Illinois Tollway Base Sheet Revisions

Section M	Base Sheet Drawings	
	Drawing	Modification Summary Effective: 03-01-2020
	Overhead Sign (OHS)-Series 720	
M-OHS-720	OVERHEAD SIGN STRUCTURE SPAN TYPE SUMMARY AND TOTAL BILL OF MATERIAL	
	Removed "Basis of Payment". Removed extra listed payitems "OVERHEAD SIGN STRUCTURE, SPAN TYPE (ALUMINUM)"	
M-OHS-721	OVERHEAD SIGN STRUCTURE CANTILEVER TYPE SUMMARY AND TOTAL BILL OF MATERIAL	
	Removed "Basis of Payment". Removed extra listed payitems "OVERHEAD SIGN STRUCTURE, CANTILEVER TYPE (STEEL)"	
M-OHS-722	OVERHEAD SIGN STRUCTURE ENTRANCE MONOTUBE TYPE (STEEL) MAINLINE SUMMARY AND TOTAL BILL OF MATERIAL	
	Added and modified new handhole openings on each side of all splices along the horizontal beam. Removed "Basis of Payment".	
	Removed extra listed payitems "OVERHEAD SIGN STRUCTURE, MAINLINE ENTRANCE MONOTUBE TYPE (STEEL)"	
M-OHS-723	OVERHEAD SIGN STRUCTURE EXIT MONOTUBE TYPE (STEEL) MAINLINE SUMMARY AND TOTAL BILL OF MATERIAL

DETAIL A

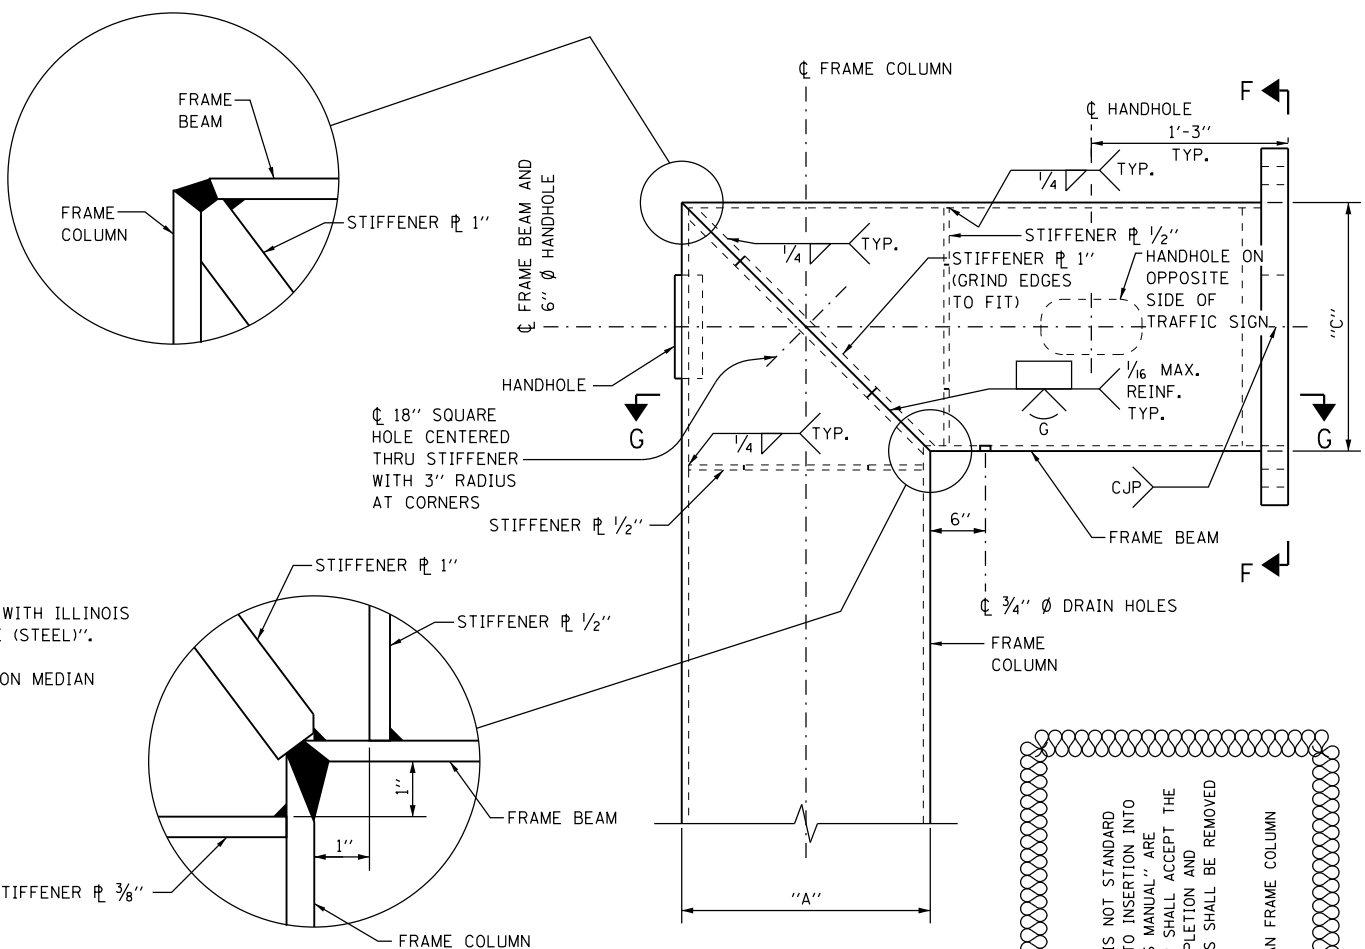
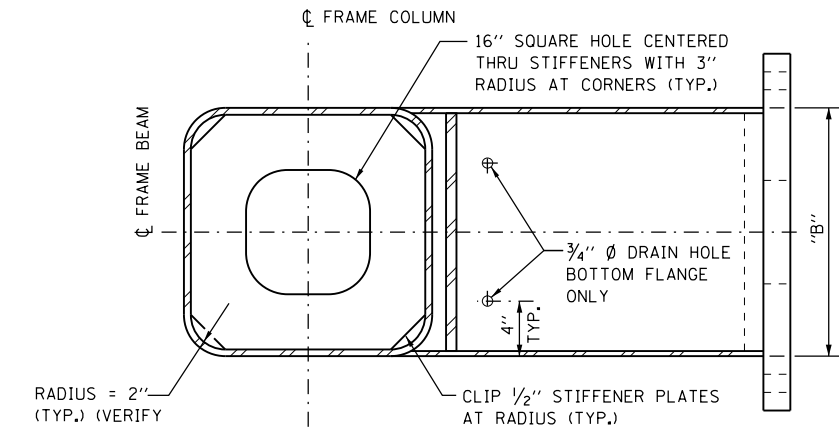
Added handhole on Detail A.	
	Added callout for washers and nuts in the column base section.	
	Revised note 3 for splice bolt and anchor bolt installation requirement.	
	Added callout to the anchor hole to refer to note 3 in View F-F	
M-OHS-729	OVERHEAD SIGN STRUCTURE ITS GANTRY FRAME (STEEL) SINGLE-SPAN STRUCTURE DETAILS SHEET 5	
	Added heavy hex locknut in the anchor bolt detail.	
M-OHS-730	OVERHEAD SIGN STRUCTURE ITS GANTRY FRAME (STEEL) TWO-SPAN STRUCTURE DETAILS SHEET 1	
	Revised Note to Designer when to use Shoulder Foundation Type I and II barrier. Removed "Basis of Payment".	
	Added and modified new handhole openings on each side of all splices along the horizontal beam. Revised Steel Tube Frame ASTM.	
M-OHS-730	OVERHEAD SIGN STRUCTURE ITS GANTRY FRAME (STEEL) TWO-SPAN STRUCTURE DETAILS SHEET 2	
	Revised base plate size in plan to match Section B-B	
	Added heavy hex lock nut to the anchor.

DETAIL A

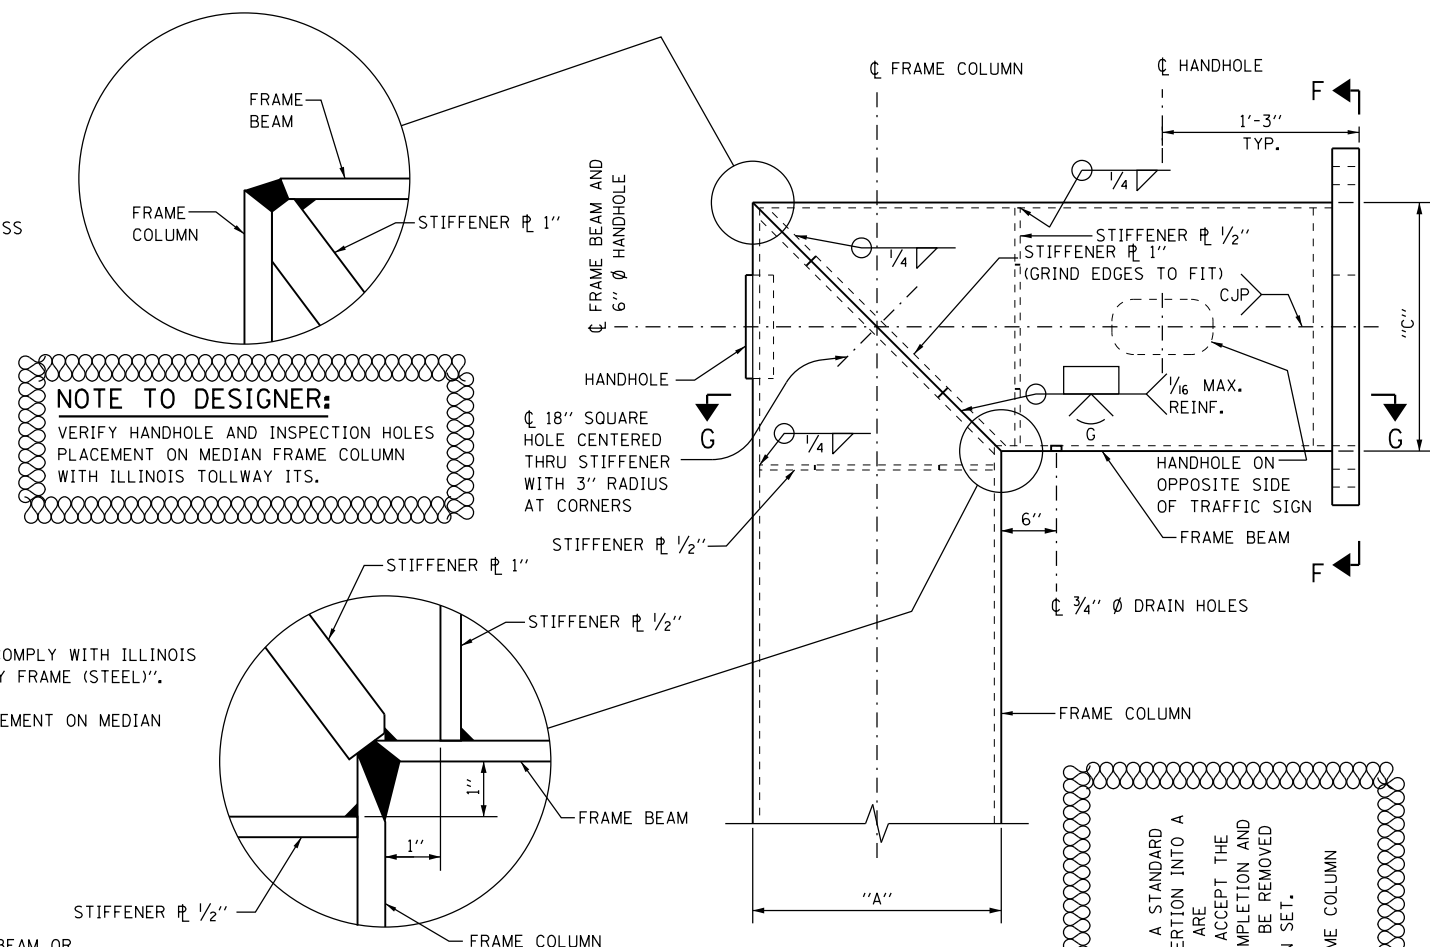
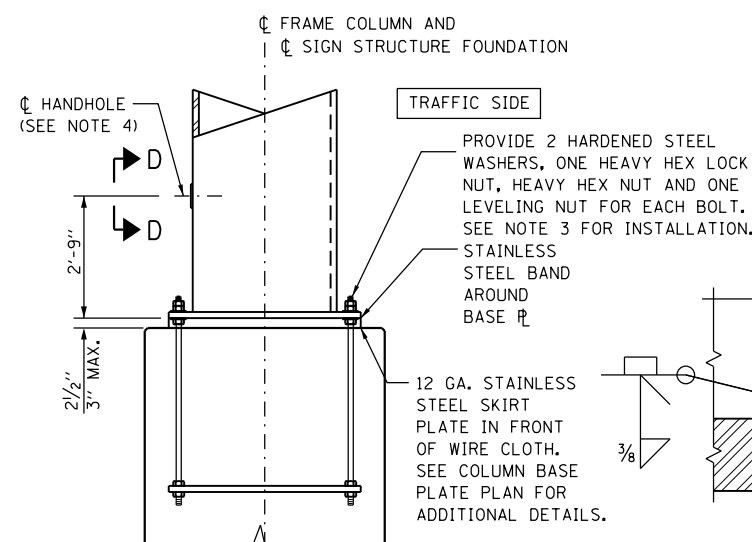
M-OHS-730	OVERHEAD SIGN STRUCTURE ITS GANTRY FRAME (STEEL) TWO-SPAN STRUCTURE DETAILS SHEET 3	
	Added handhole on Detail A.	
	Added callout for washers and nuts in the column base section.	
	Revised Note 3 for splice and anchor bolt installation requirement.	
	Added callout to the anchor hole to refer to note 3 in View F-F	
M-OHS-730	OVERHEAD SIGN STRUCTURE ITS GANTRY FRAME (STEEL) TWO-SPAN STRUCTURE DETAILS SHEET 6	
	Added heavy hex locknut in the anchor bolt detail.
